Notice Of Proposal: Fairford Speed Limits

Consultees	Comments
XXXXXXXXXX	<p>As a resident of Fairford who currently lives to the east in XXXXXXXXXXXX (currently a 40mph limit) I would strongly support and welcome this proposal. Vehicles currently break the speed limit on this road causing a number of accidents in the last 3 years since we moved here, and making crossing of this road dangerous. The increase of both the 30 and 40 mph zones entering this end of fairford will hopefully slow traffic down considerably.</p> <p>The only amendments I would like to see are:</p> <ol style="list-style-type: none"> 1. There are no pedestrian crossings over the A417 from near Morecombe Way and many people travel on foot to and from this estate due to the public footpaths at the rear and parents and children walking to school. The reduced speed limit would make this easier but a pedestrian crossing would be even better! I appreciate that this may be a different department or consultation. 2. I would ask that the speed limit within the estate is considered for reduction from 30mph as current to 20mph due to the residential nature and the fact that it is a no- through road and to take into account

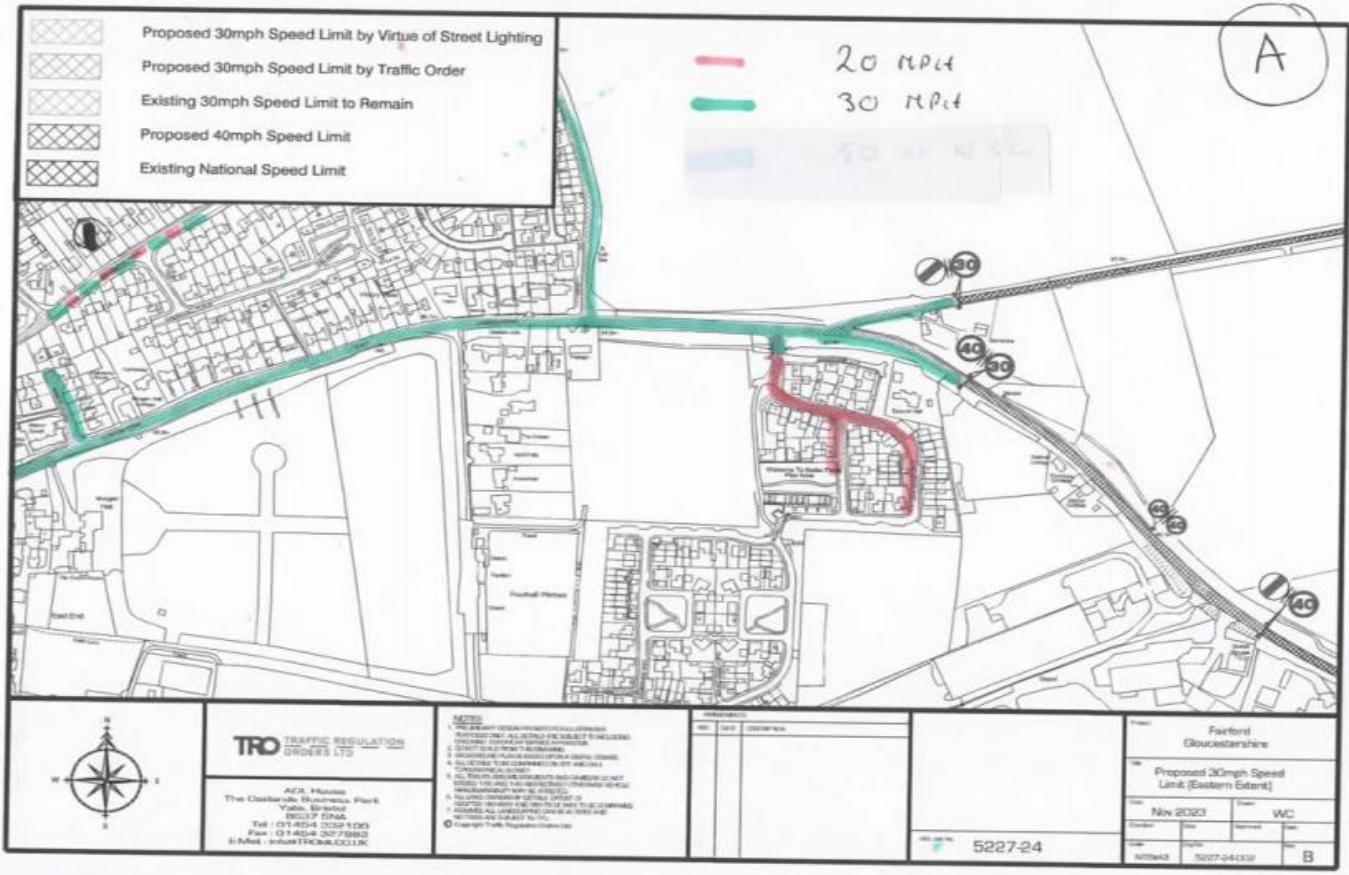
PLAN A

30mph reasonable along London Road as there are adequate pavements most of the way for children accessing Keble Fields

Point 1 Hatherop Road Possibly the road as far as the junction with Hatherop Lane should be 20mph as it is well used by children, though it does have adequate pavements. Prefer 20 mph to proposed 30mph. This needs further consideration.

PLAN B

All central area of FAIRFORD should be 20mph.

Point 1 The 20mph should extend along Leafield Road to a short way beyond the entrance to Farmors School. This is a very busy road, being the main entrance to both the Primary and Secondary School and a difficult junction (being on a bend) at the corner of the Walnut Tree field. Parents park along it at school starting and leaving times

Point 2 Some house doors open directly onto the road and some have driveways which are difficult to enter and exit with limited visibility. The pavement is only on one side of the road and is very narrow. The 20mph should extend to at least the junction with Queensfield or preferably the junction with Hatherop Lane and see my comments in Plan A Point 1.

Point 3 The 20 mph should continue beyond the Railway Inn. Cars park outside the Inn and there is a difficult junction beside it because of cars parked outside the houses in Lower Croft. It is a very busy road and difficult for pedestrians to cross.

Point 4 There is no pavement on the stretch of road from London Street to Lower Croft making it extremely dangerous for pedestrians.

Point 5 It is a very difficult piece of road from the High Street to the Town Bridge, with very narrow pavements with the part of the road just before the turning into the High Street having no pavement at all. Visibility is very difficult.

Point 6 From the Town Bridge as far as the junction with Coronation Street should also be 20mph. Many houses open directly onto the pavement. The road is very busy and there is a danger of the car doors of residents parking outside their houses opening directly onto the road.

Point 7 The 20mph should continue past the top of the high street to the junction with Coronation Street. People stand on the bridge to feed the ducks and it is a popular tourist spot. There is no pavement by the mill so pedestrians must walk in the road. There is a thin pavement starting by the Oxpens but in the summer this does not accommodate the number of adults and children using the road. The top end of the road is very windy with little visibility. There is a footpath for pedestrians but cyclist use the road and it is difficult for cars to see them.

PLAN C

Point 1 I am undecided about the road I have marked green and pink. Although Coronation Street is quite wide it connects to the top of the road from the Mill so it would make sense for the 20mph to have continuity. The part of the road towards Horcott is very narrow and at its mouth is impossible for vehicles to pass. There is an Industrial Estate further up the road so it is used by large vehicles. The pavements are VERY narrow so consideration

Point 2 Following on from Point 1, there are houses opening directly onto the road to Quenington so the 20mph should extend to beyond the last house. Also the road towards Honeycombe Leaze is narrow and bendy with houses directly onto to pavement and with new housing in the area, so it would make sense for the 20mph to extend to beyond the last house in that area.

Point 3 It is pointless to have such a short area of the road with a 40mph. The 30mph should start just beyond the road junction.

Excellent Plan BUT Please Extend the 20mph restriction area

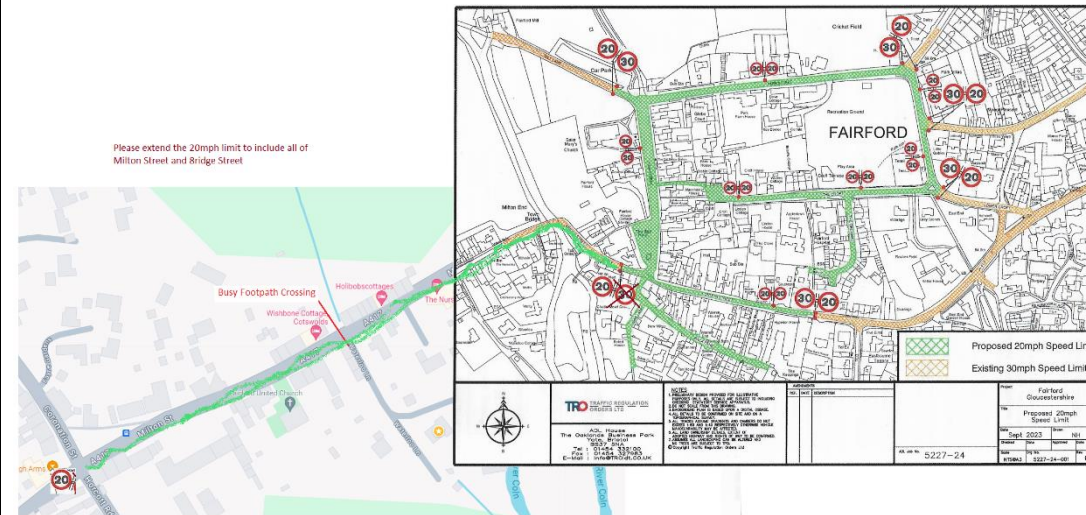
Please extend the 20mph restriction to include all of bridge street and all of Milton Street

This section of road is dangerous for pedestrians and drivers - especially those new to the area..

- The Cross Roads where Horcott Road/Coronation Street meet Milton Street are very busy, it's hard for drivers turning out of Horcott Road to see oncoming traffic and it will be busier when the Coln School development is completed.
- There is a busy footpath crossing Milton Street to Waterloo Lane, which because of parking in Milton Street is 'blind' and pedestrians step-out between parked cars.
- The town bridge bend forces cars and trucks to cross the central line and or go over the pavement. Pedestrians *'feel the breath'* of passing cars and lorries.

Maintaining the 20mph from the Marlborough pub along through to London St would make Fairford a far safer town.
